TRANS/WP.29/2005/35
7 April 2005

**DRAFT CORRIGENDUM 3 TO SUPPLEMENT 15 TO THE 04 SERIES OF AMENDMENTS
TO REGULATION No. 16**

(Safety-belts)

Transmitted by the Working Party on Passive Safety (GRSP)

Figure 1 - ISO/F3 envelope dimensions for a full-height forward-facing toddler CRS (height 720 mm) ISOFIX SIZE CLASS A

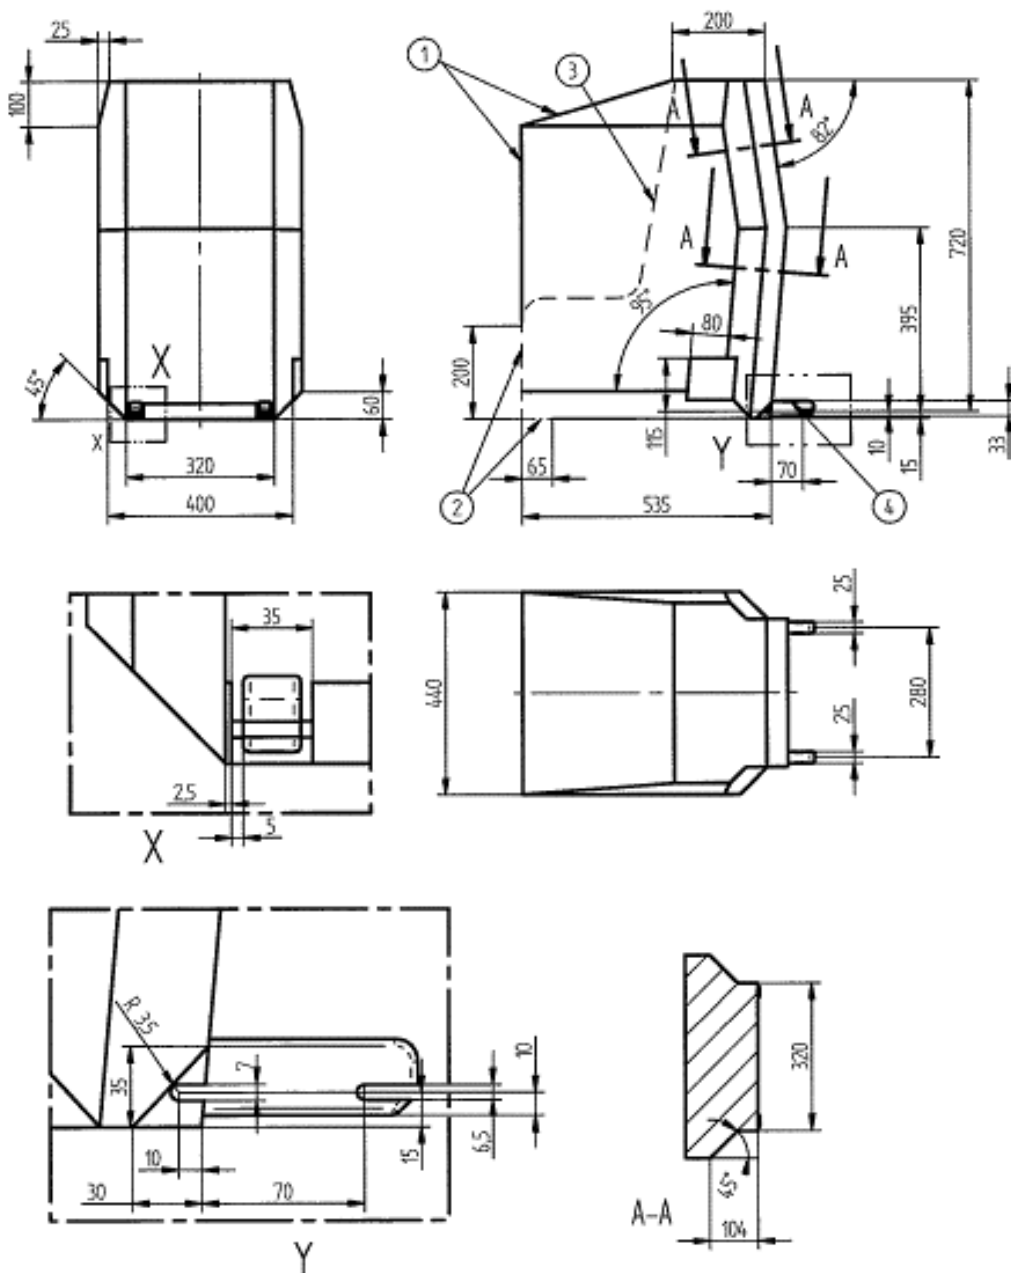
Annex 17 – Appendix 2, paragraphs 4.1. to 4.7., amend to read:

"4.1. Full-height forward-facing toddler child restraint systems envelope

- 1 Limits in the forward and upwards directions
- 2 Dashed line marks area where a support leg, or similar, is allowed to protrude
- 3 N/A
- 4 Further specifications of the connector area are given in Regulation No. 44

Figure 2 – ISO/F2 envelope dimensions for a reduced-height forward-facing toddler CRS, (height 650 mm) – ISOFIX SIZE CLASS B

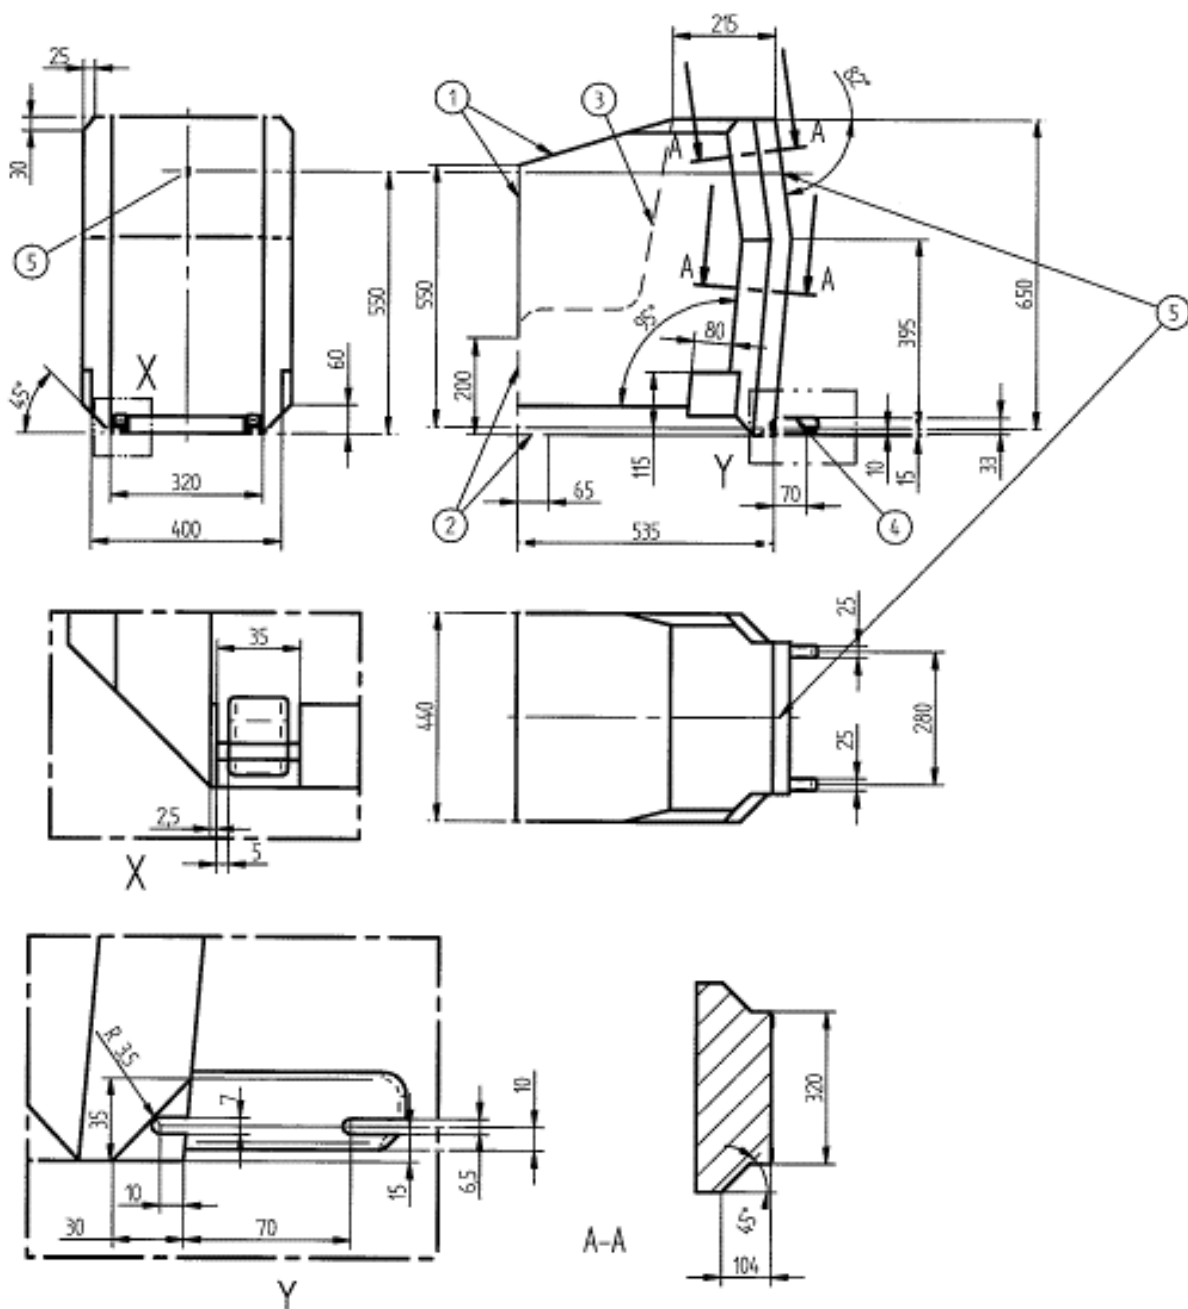
4.2. Reduced-height forward-facing toddler child restraint systems envelope

- 1 Limits in the forward and upwards directions
- 2 Dashed line marks area where a support leg, or similar, is allowed to protrude
- 3 N/A
- 4 Further specifications of the connector area are given in Regulation No. 44
- 5 Attachment point for the top tether strap

Figure 3 – ISO/F2X envelope dimensions for a reduced-height second version back surface shape forward-facing toddler CRS, (height 650 mm) – ISOFIX SIZE CLASS B1

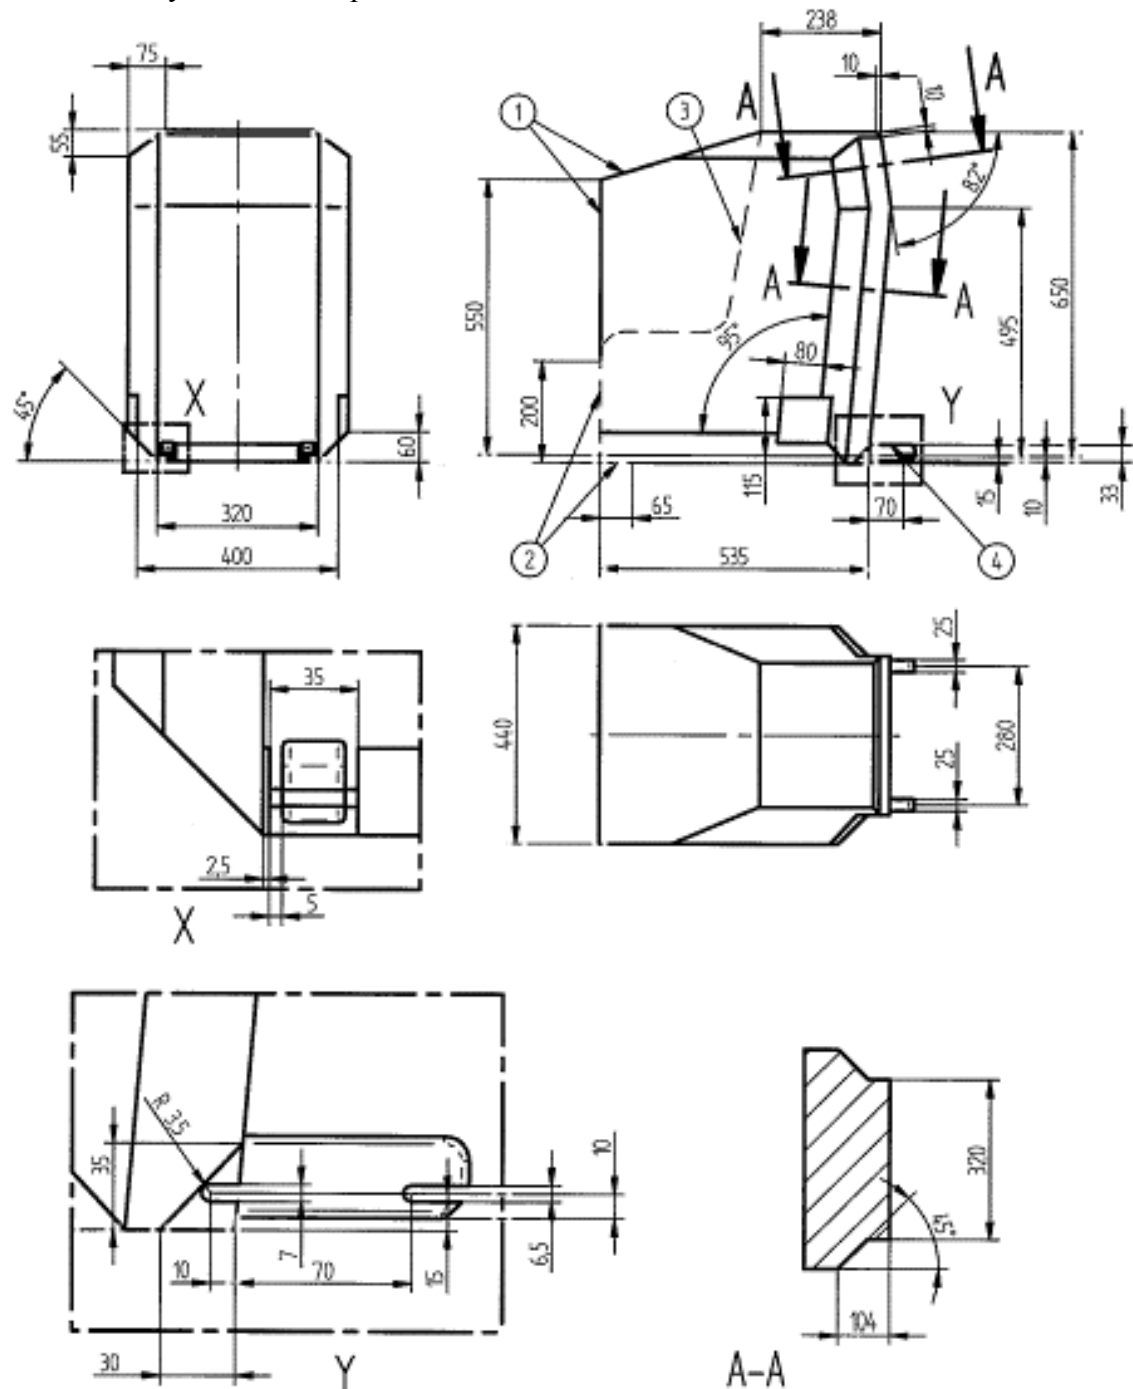
4.3. Reduced-height second version back shape forward-facing toddler child restraint systems envelope

- 1 Limits in the forward and upwards directions
- 2 Dashed line marks area where a support leg, or similar, is allowed to protrude
- 3 N/A
- 4 Further specifications of the connector area are given in Regulation No. 44

Figure 4 - ISO/R3 envelope dimensions for a full-size rearward-facing toddler CRS
ISOFIX SIZE CLASS C

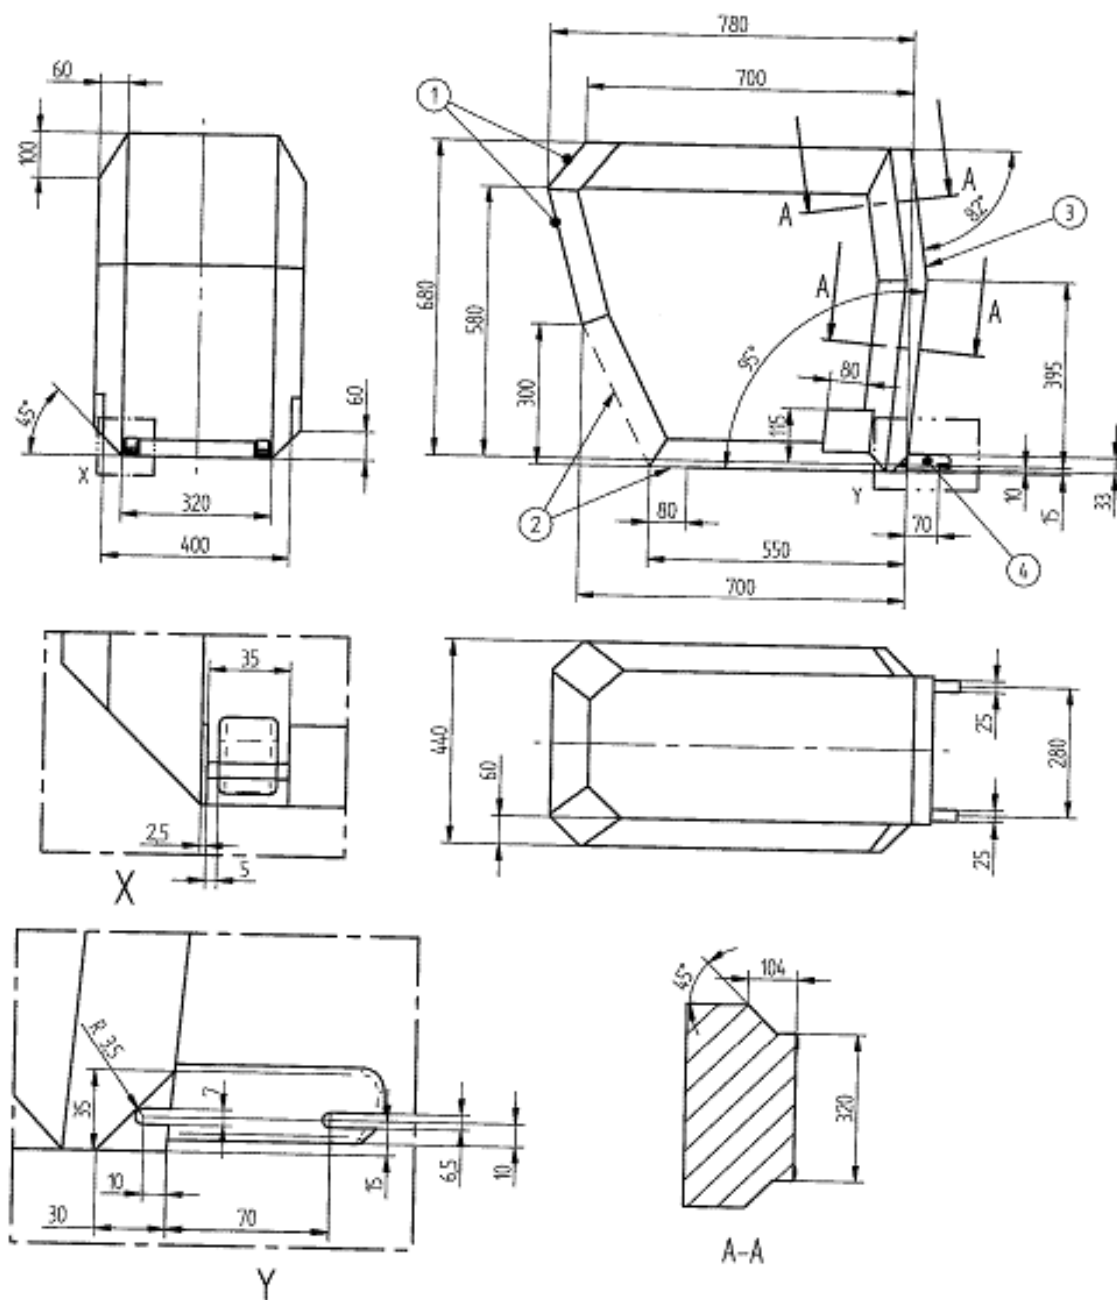
4.4. Full-size rearward facing toddler child restraint system envelope

- 1 Limits in the rearward and upwards directions
- 2 Dashed line marks area where a support leg, or similar, is allowed to protrude
- 3 The backwards limitation (to the right in the figure) is given by the forward-facing envelope in Figure 2
- 4 Further specifications of the connector area are given in Regulation No. 44

Figure 5 - ISO/R2 envelope dimensions for a reduced-size rearward-facing toddler CRS
ISOFIX SIZE CLASS D

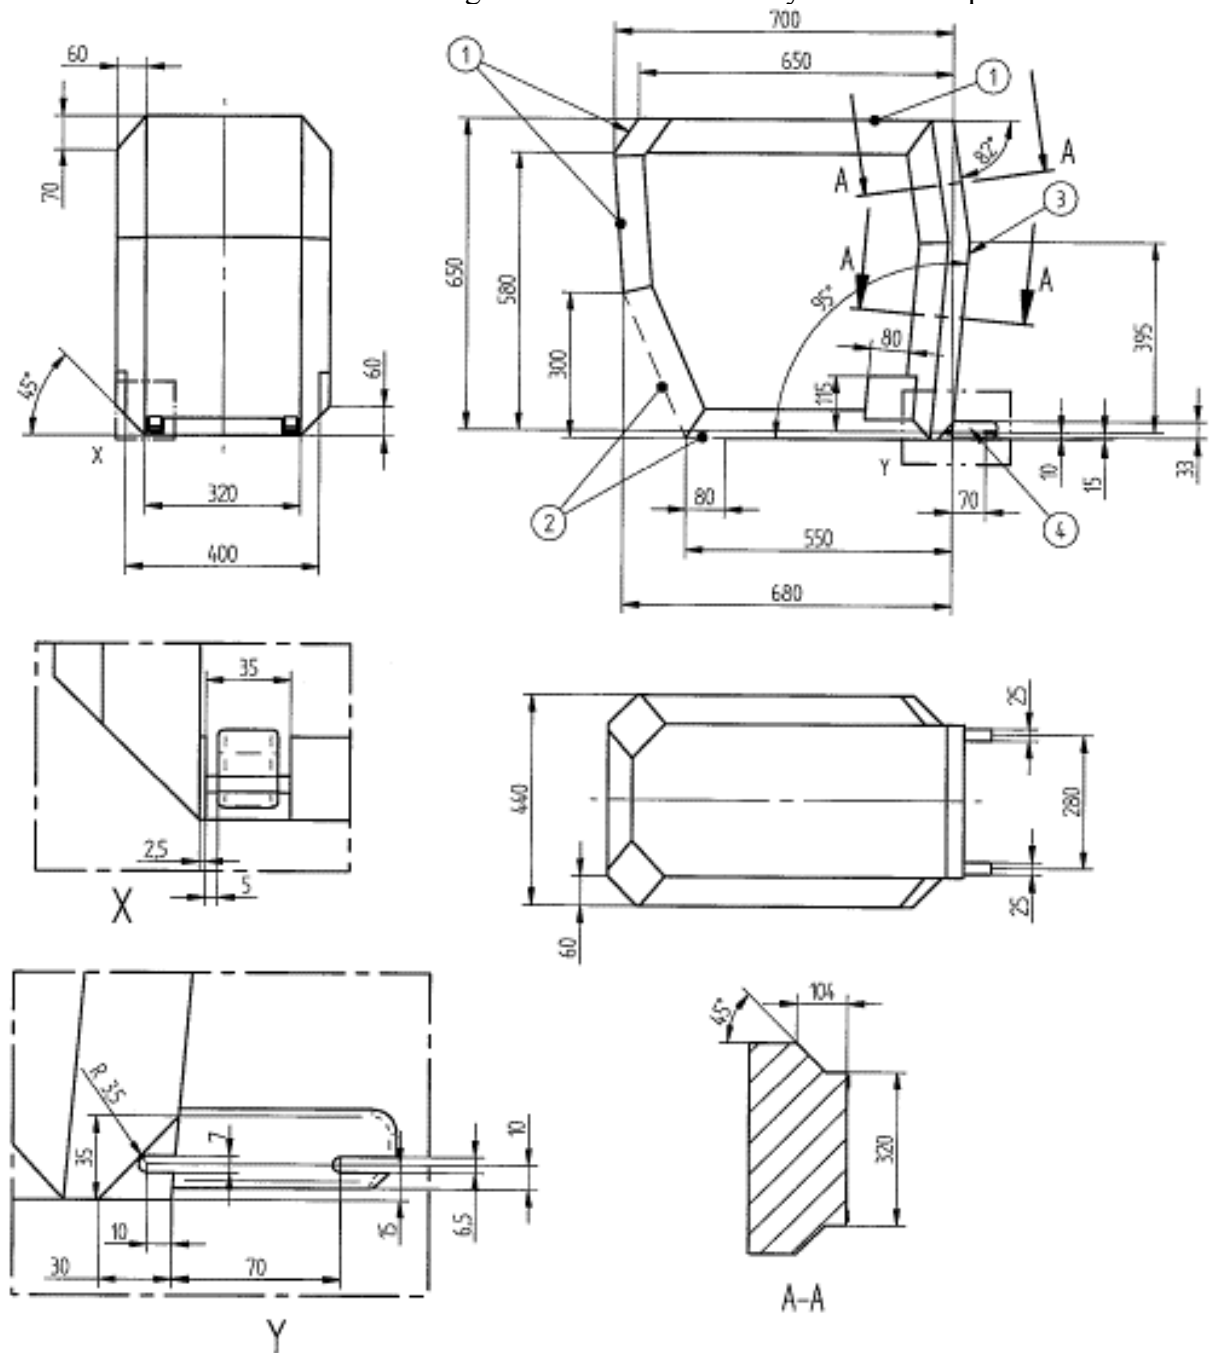
4.5. Reduced-size rearward-facing toddler child restraint systems envelope

- 1 Limits in the rearward and upwards directions
- 2 Dashed line marks area where a support leg, or similar, is allowed to protrude
- 3 The backwards limitation (to the right in the figure) is given by the forward-facing envelope in Figure 2
- 4 Further specifications of the connector area are given in Regulation No. 44

Figure 6 – ISO/R1 envelope dimensions for an infant-size rearward-facing CRS ISOFIX SIZE CLASS E

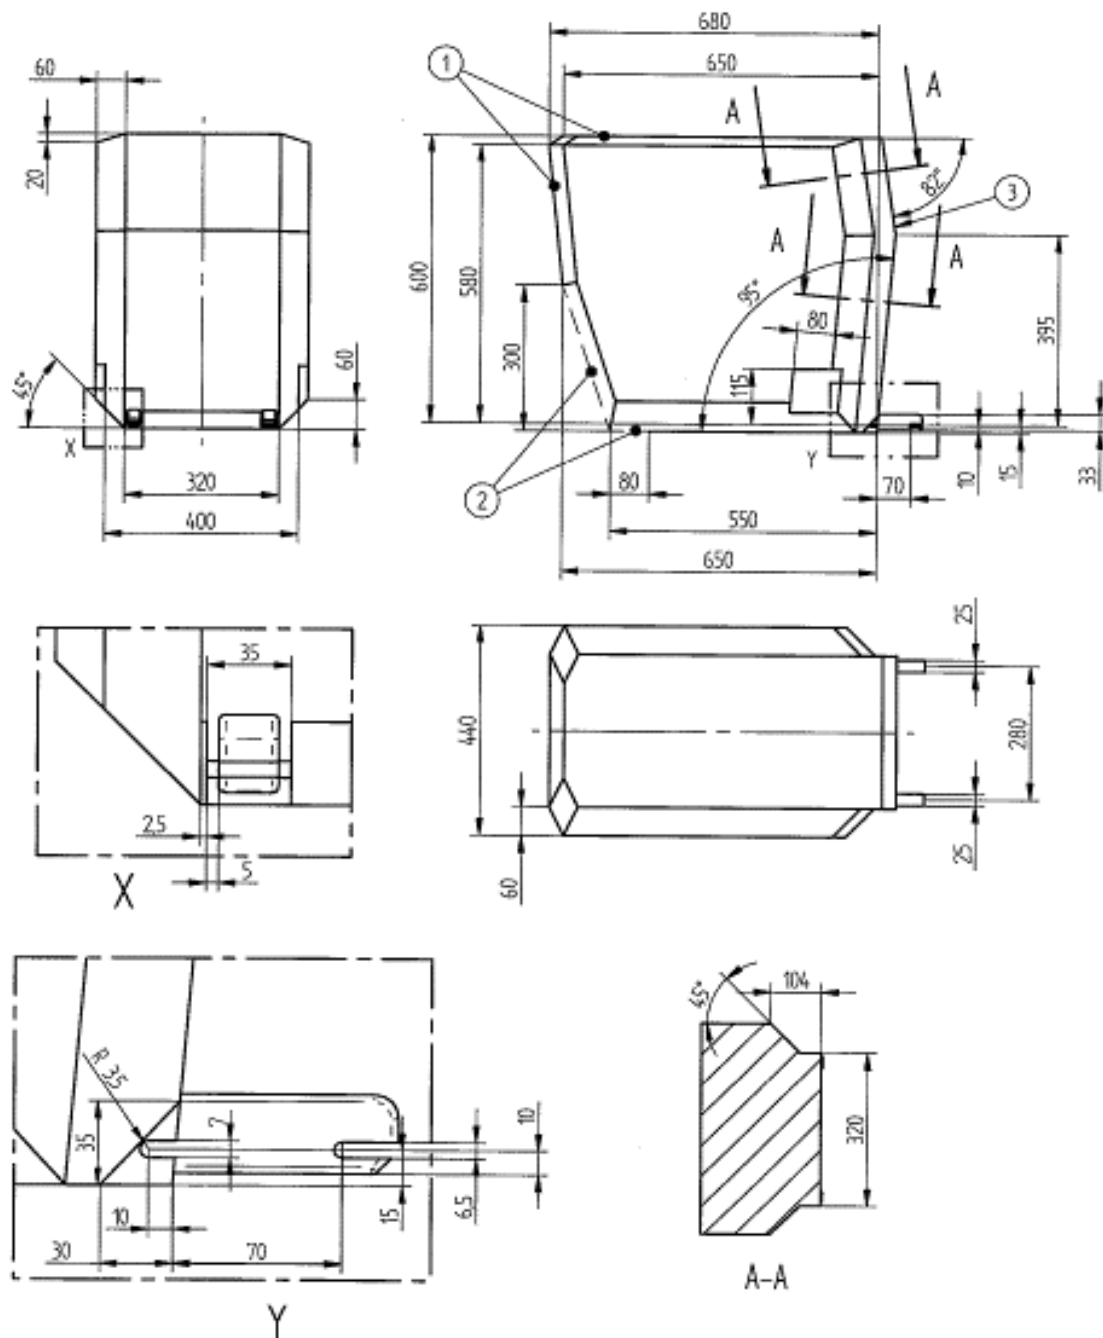
4.6. Rearward facing infant child restraint systems envelope

- 1 Limits in the rearward and upward directions
- 2 Dashed line marks area where a support leg, or similar, is allowed to protrude
- 3 The backwards limitation (to the right in the figure) is given by the forward-facing envelope in Figure 2
- 4 Further specifications of the connector area are given in Regulation No. 44

Figure 7 – Envelope dimensions for lateral facing position CRS - ISO/L1- ISOFIX SIZE CLASS F or symmetrically opposite – ISO/L2 – ISOFIX CLASS G"

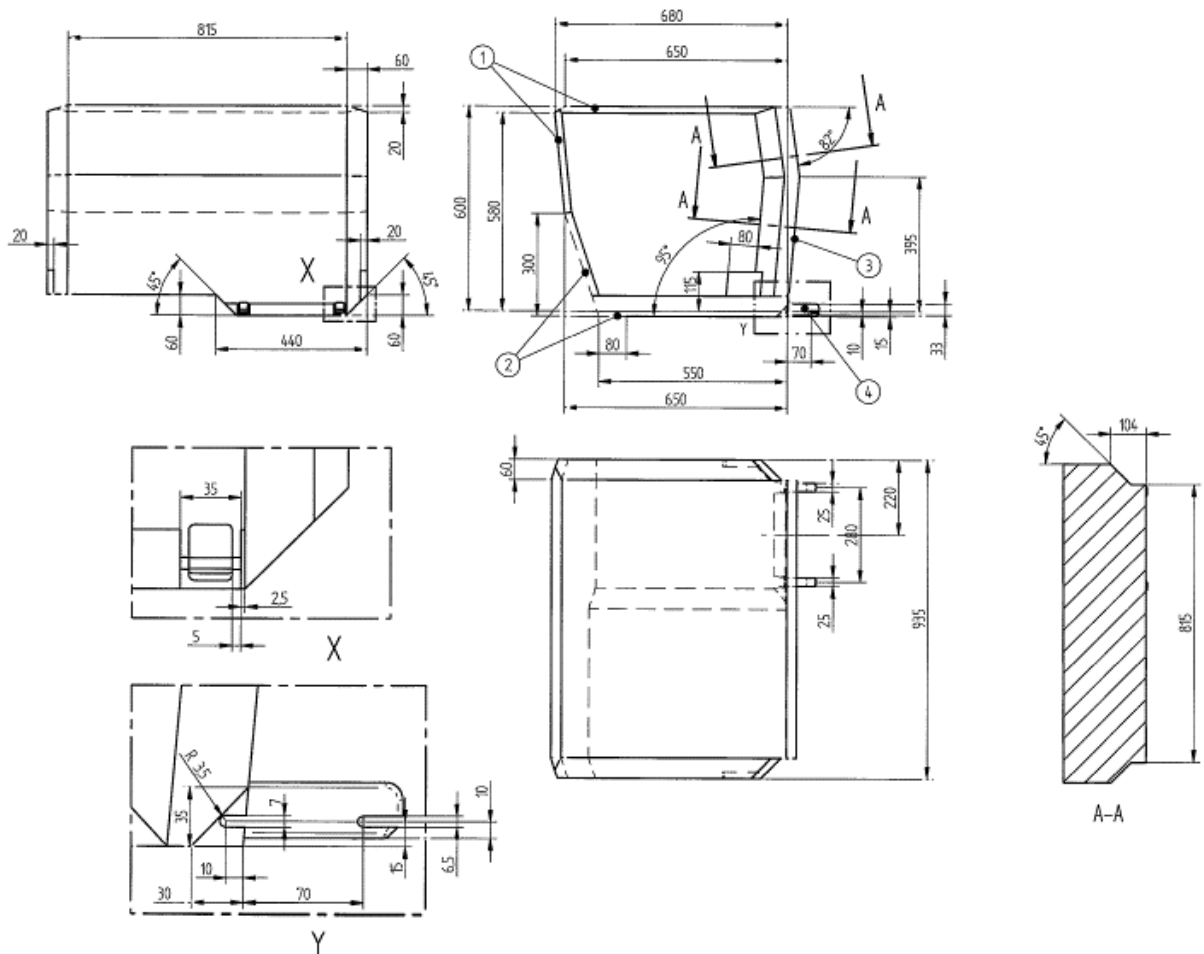
4.7. Lateral facing child restraint systems envelope

- 1 Limits in the rearward and upward directions
- 2 Dashed line marks area where a support leg, or similar, is allowed to protrude
- 3 The backward limitation (to the right in the figure) is given by the forward-facing envelope in Figure 2
- 4 Further specifications of the connector area are given in ISO 13216-1, Figures 2 and 3
